Team Update 09

Game and Season Manual

Team Update 08

Team Update 07

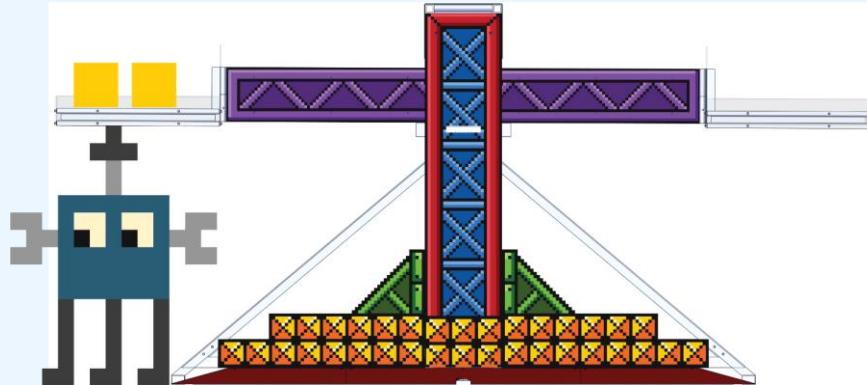
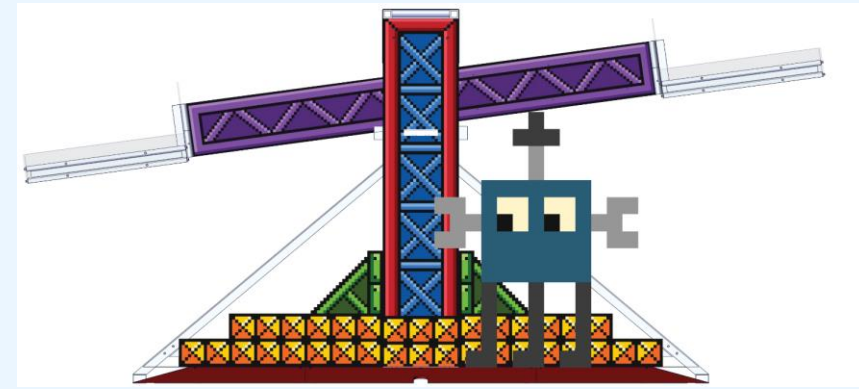
The intent of G25 is to make it clear that PLATES are to move solely because of POWER CUBE weight and not because of a ROBOT deliberately trying to move PLATES (either by using its own manipulator, or a POWER CUBE as an extension of the ROBOT, to push or hold a PLATE).

The “momentary” and “minimal” language in G25 is subjective but necessary because ROBOTS may cause PLATE movement (or prevent PLATE movement) as they place POWER CUBES and bump PLATES, get hit, etc.

Generally, “momentary” means near instantaneous, or in other words, contact for less than approximately one (1) second and “minimal” means a displacement of fewer than approximately three (3) in. However, REFEREES are not expected to measure, and be accountable to, real-time PLATE displacement or precise timing from their vantage points.

Example 1: A ROBOT may not hold the SCALE PLATE in a “balanced” state.

Example 2: A ROBOT may not hold a plate up.

Figure 3-14: SWITCH PLATE dimensions

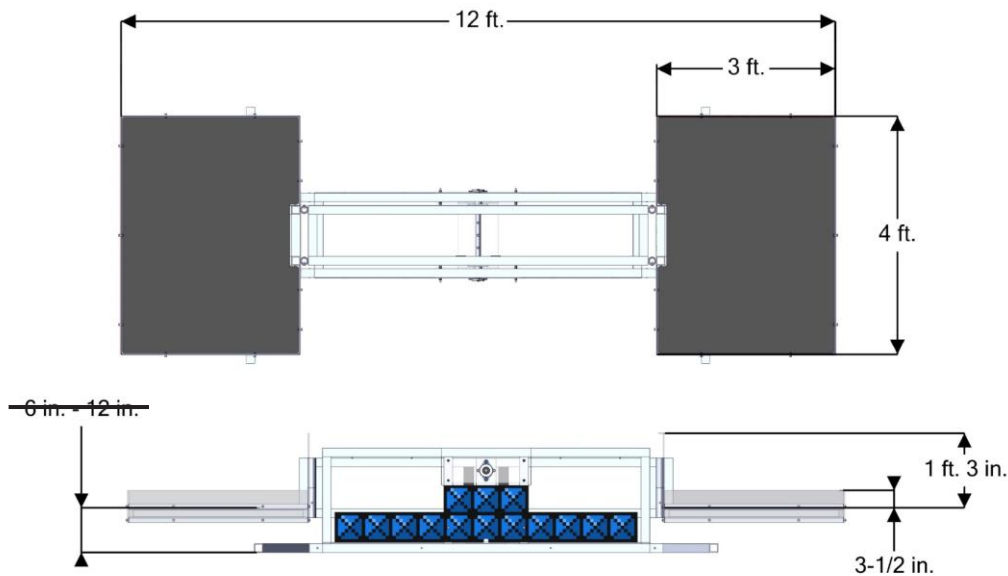
Figure 3-14 has been updated to remove the lower left dimension, which doesn't add value.

Figure 3-4: The SCALE (Note, cable protectors are shown, but are not part of the SCALE)

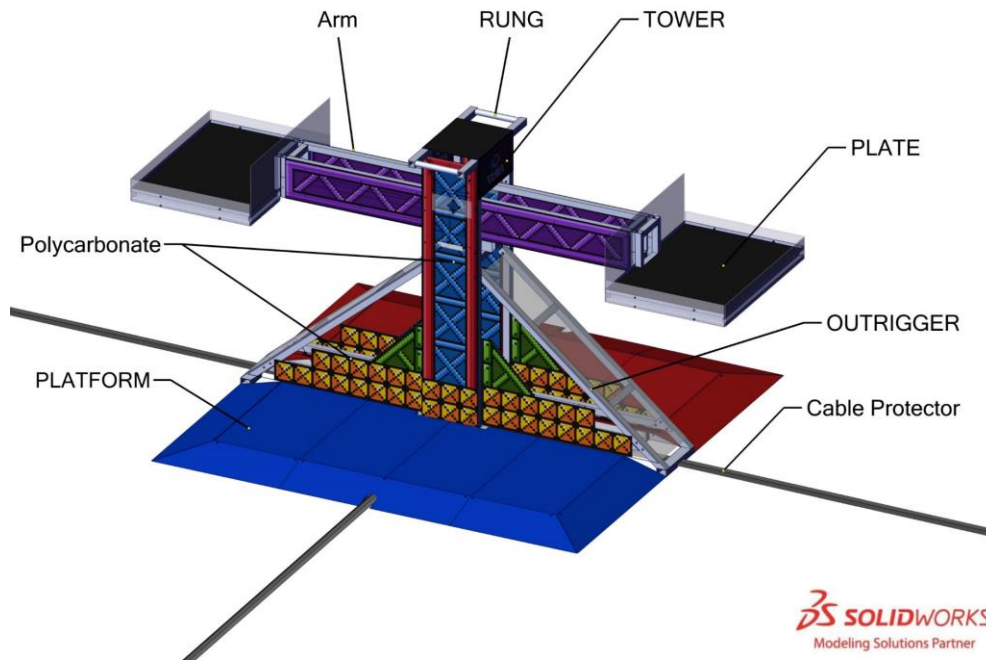
The BRICKS are graphics depicting golden squares surrounded by a black outline that extends 12 in. (~30cm) above the **horizontal** surface of the PLATFORM.

Figure 3-11: PLATFORM top length and width dimensions

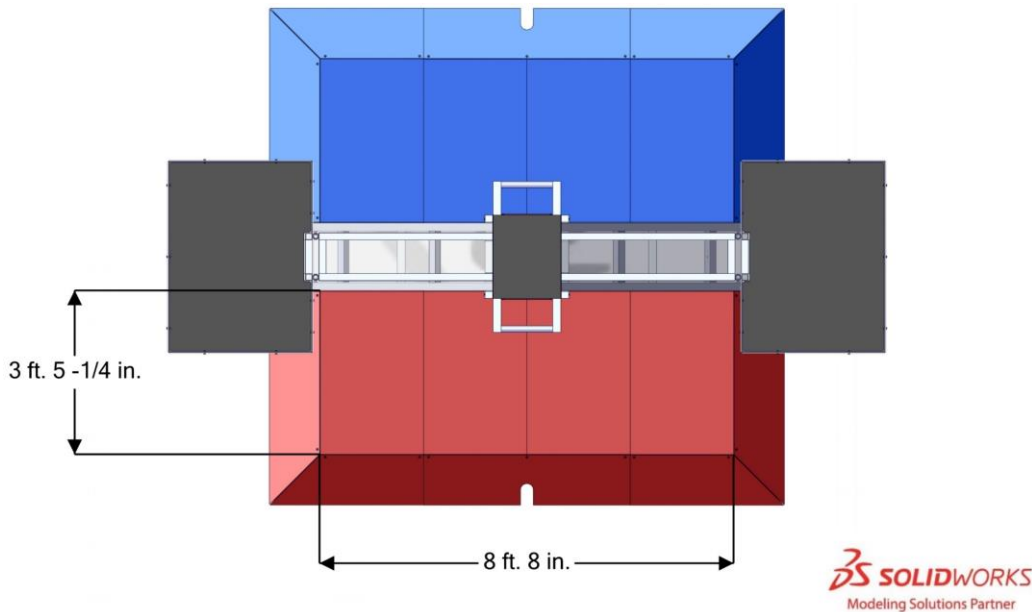
Located at the base of the SCALE, on each side, is a PLATFORM covered with ALLIANCE colored HDPE. The TOWER and OUTRIGGERS separate one PLATFORM from the other. Each PLATFORM top is 8 ft. 8 in. (~264 cm) wide by 3 ft. 5 ¼ in. (~105 cm) deep and 3 ½ in. (~9 cm) tall. The ramps leading to the PLATFORM includes ramps with a run of 1 ft. 4 ¾ in. (~33 32 cm) and long with a 15.35 deg. angle. The ALLIANCE colored tape that abuts the PLATFORM ramps is part of the PLATFORM.

Figure 4-1 Possible PLATE assignments

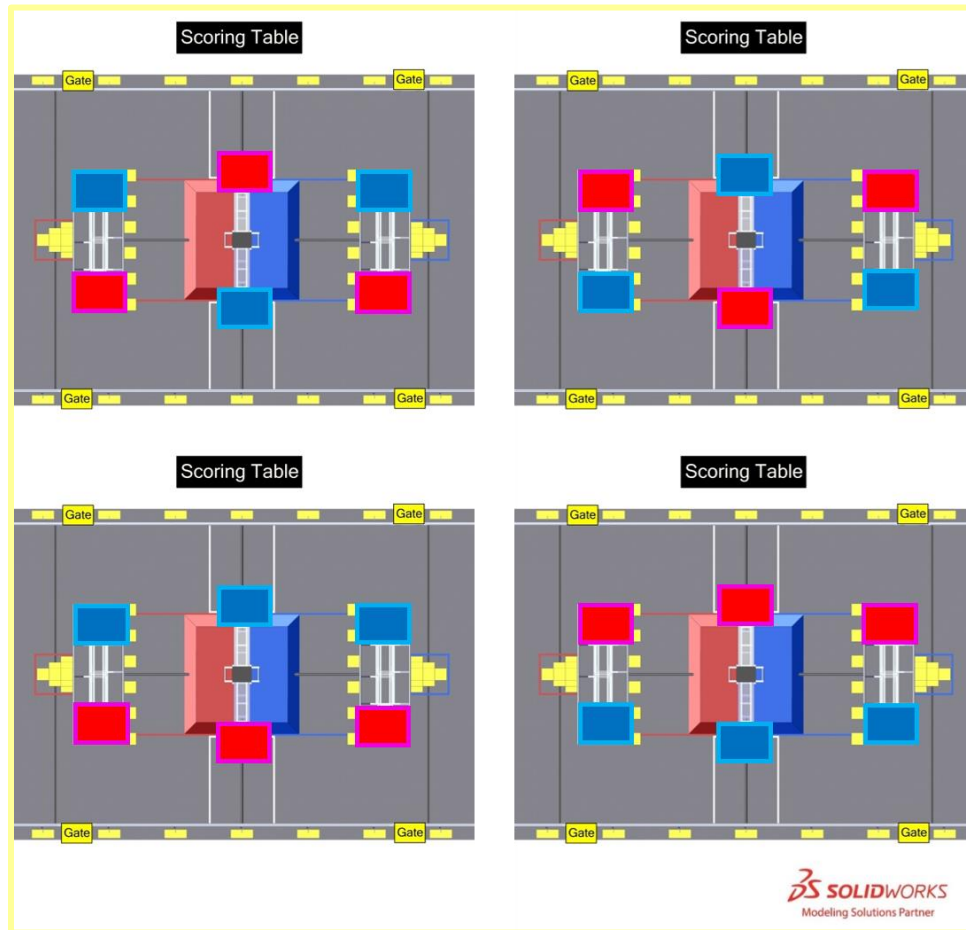
Each MATCH is divided in to two stages. The first stage, called Autonomous (AUTO), is the first fifteen (0:15) seconds of a MATCH in which ROBOTS operate without any DRIVE TEAM control or input. Prior to the start of AUTO, the assignments of ALLIANCE colors for SWITCH and SCALE

PLATES are randomized among the four states in Figure 4-1 and transmitted to the OPERATOR CONSOLE by the Field Management System (FMS). During AUTO, ROBOTS attempt to deliver preloaded POWER CUBES to PLATES, retrieve additional POWER CUBES from around the FIELD, and cross their AUTO LINE any time before the end of the stage.
